REVIEW COMMENT TABLE

Diavik - WL Amendment - PK to Mine Workings - DDMI Response to WLWB Information Request (W2015L2-0001) (WLWB)

DDMI provided its Response to the WLWB's IR on November 6, 2018.

Figure 5. Monitored daily temperature data for Lac de Gras (May 10, 2013 to September 6, 2013; April 19, 2016 to September 18, 2016) and for Snap Lake (2006 to 2017)

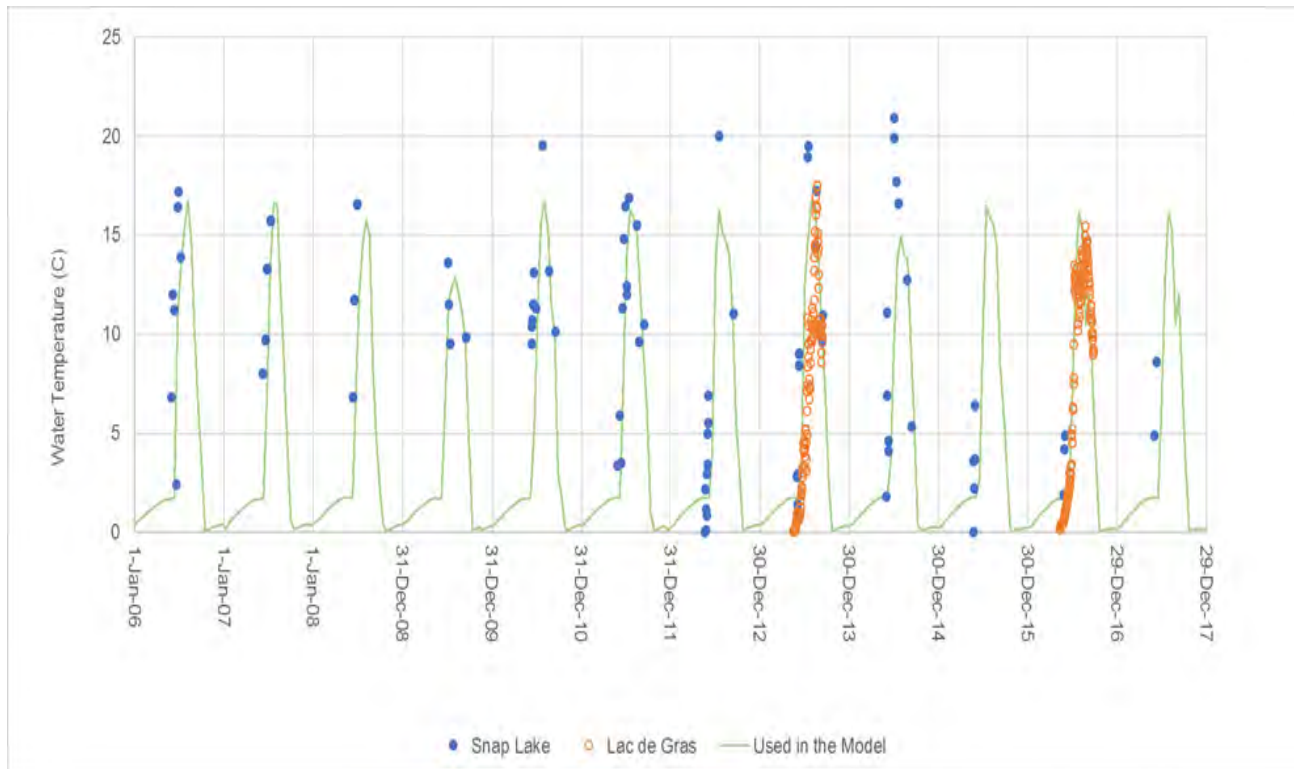
11	Temperature	<p>Comment In DDMI's Water Quality Modelling report, Section 2.2.4.1, DDMI states that there were no observable water temperature data for Lac de Gras, and therefore used a temperature time-series was developed using data from Snap Lake dated from 2008 and 2012. ENR notes that temperature data are available in the field notes for each AEMP water quality sample. These include temperatures for grab samples and temperature depth profiles. It has been shown that temperature differences have been noted in different parts of Lac de Gras (Golder, 2014, 2017) and temperature is a key driver of water stability.</p>	<p>Jan 8: The hydrodynamic model requires daily input time series of water temperature, which was not available for Lac de Gras for the long-term period. The available monitored daily temperature data for Lac de Gras (May 10, 2013 to September 6, 2013 (Golder 2014); April 19, 2016 to September 18, 2016 (Golder 2017) is plotted (see Figure 5 in Attachment #9) against the monitored data for Snap Lake (2006 to 2017) and the continuous time series used in the hydrodynamic model. The continuous time series was developed based on Snap Lake data:</p> <ul style="list-style-type: none"> • for each month, an average monthly temperature was calculated from available data

Figure 6 – Left: Turbidity profiles from Springer Pit and Right: Beartooth Pit

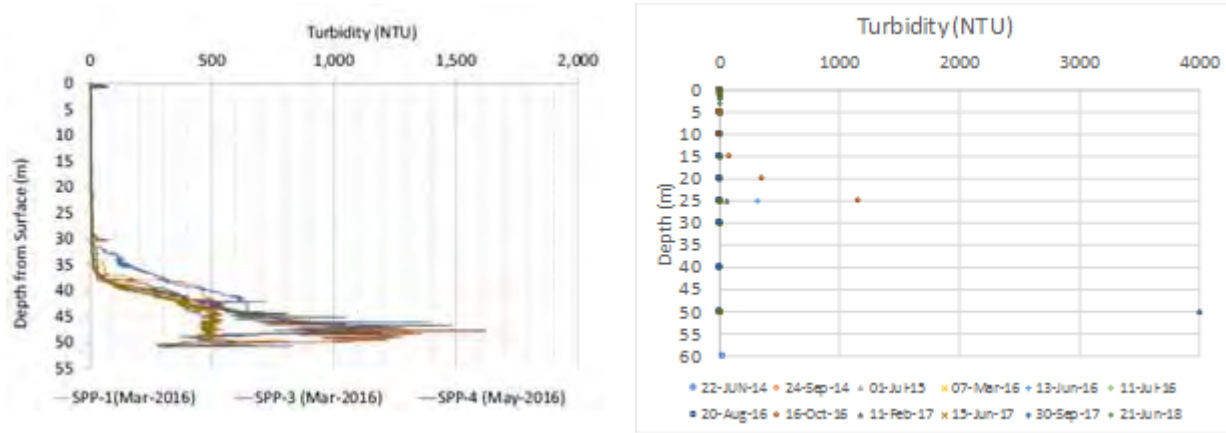
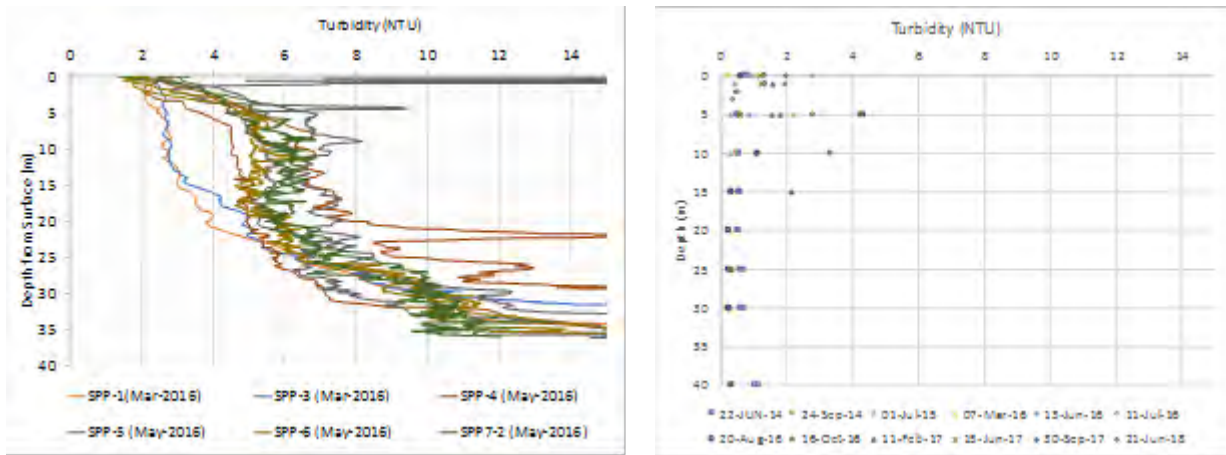
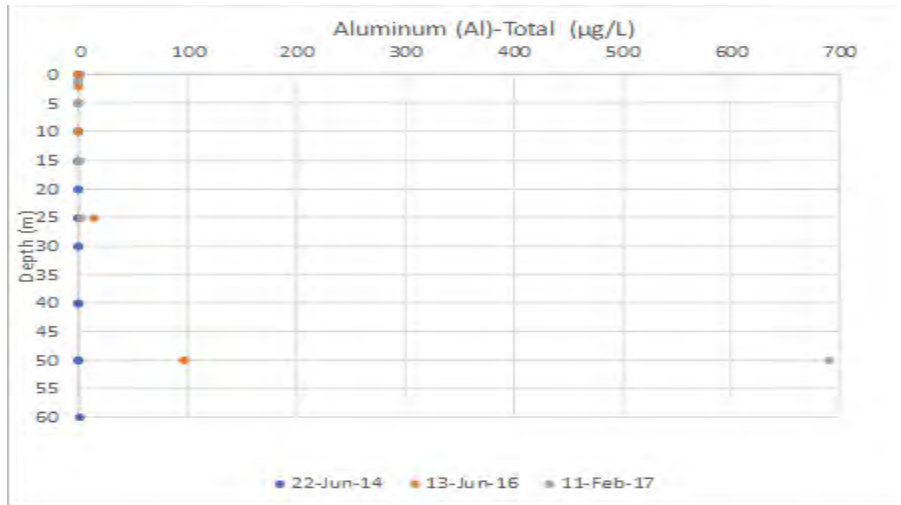
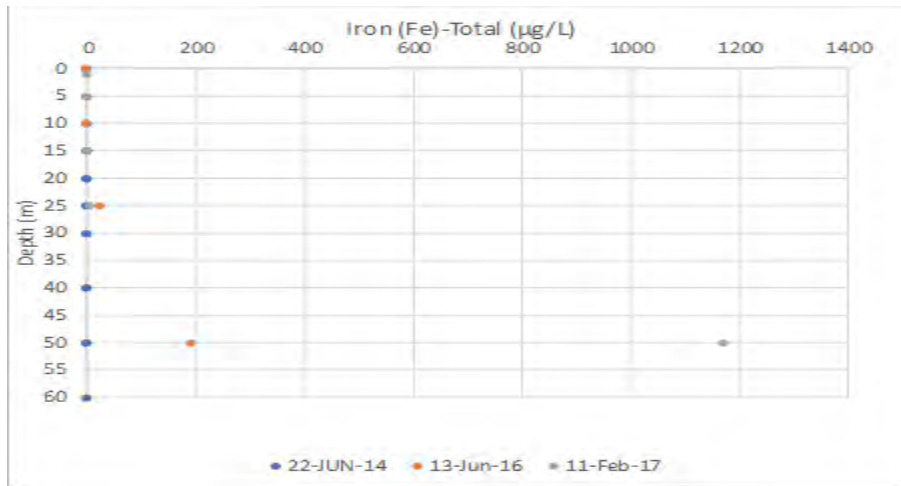
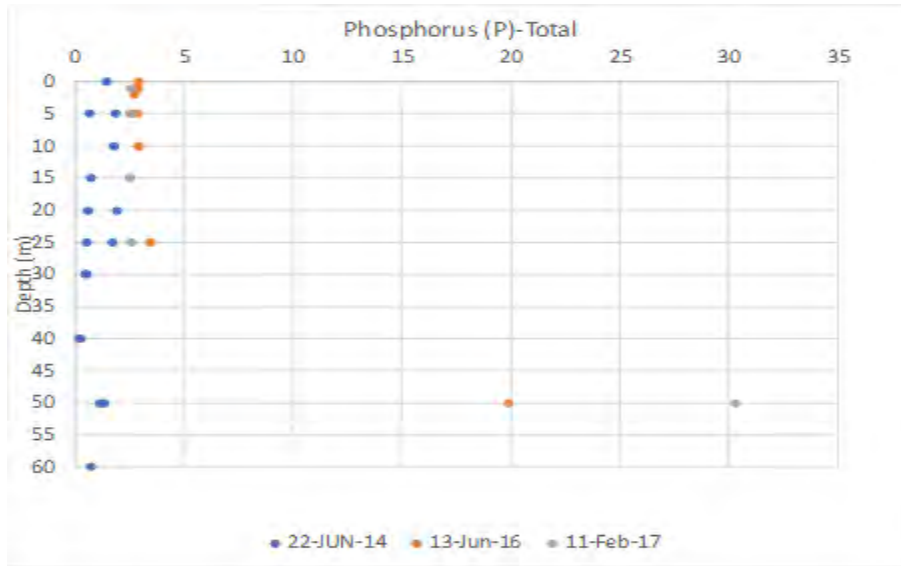
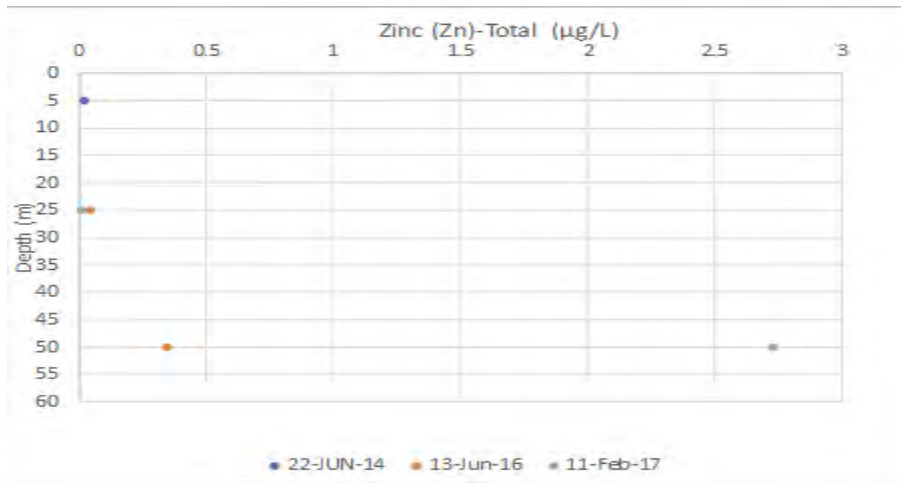
2	PK Characterization	<p>Comment The model was run using a generic settleable water quality constituent to evaluate the resuspension of fines associated with turbulent mixing of the lake (Golder memo, page 3). However, very little information is provided on the characteristics that are represented by the settleable material (e.g., particle size).</p> <p>Recommendation To better support the conclusion that a 20 m water cap is sufficient to prevent resuspension of fines, demonstrate that the generic 'settleable' tracer used in the modelling is representative of PK characteristics expected to be deposited to the pits.</p>	<p>Jan 8: The generic settleable constituent in CE-QUAL-W2 represents a discrete fraction of material, whereas the actual material is distributed along a continuum of particle sizes. The CE-QUAL-W2 demonstrates a conceptual notion of particle settling and is not intended to demonstrate the full range of particle behaviour – that is beyond the scope of that model. A stronger line of evidence is the analog data, as shown in the response to WLWB-3.</p>

3	PK Characterization	<p>Comment To further support that little resuspension is expected with a 20 m water cap, a number of literature references were cited (Golder memo, page 15). All analogues identified in these references are metal mines (i.e., Colomac, Equity Silver, Faro, Mt. Polley and Premier Gold).</p> <p>Recommendation (1) Demonstrate that cited mines are appropriate analogues. (2) Are better analogues available, such as other pits backfilled with PK or PK storage facilities? (3) Are settling tests available from the A21 pit and other remaining underground areas to draw comparisons with other facilities? If so, please provide these results and comparisons. If not, please describe the feasibility and time requirements for completing such tests.</p>	<p>Jan 8: To consider whether the cited analogs are appropriate, turbidity profile data from Ekati's Beartooth Pit were evaluated alongside the cited empirical data from Vandenberg and Litke (2017). Turbidity provides an indirect measure of all particulate matter in the water column. The comparison is shown in Figure 6 at similar scales to show all data, and the data are shown in Figure 7 in finer scale to provide resolution at the low turbidity measured within the top 40 m of water. The comparison shows that Beartooth Pit has a similar overall pattern of turbidity and therefore a similar pattern of suspended particulate matter. In both pits, the majority of the water column has low turbidity (about 5 NTU in Springer Pit and 1 NTU in Beartooth Pit). Both pits occasionally have</p>
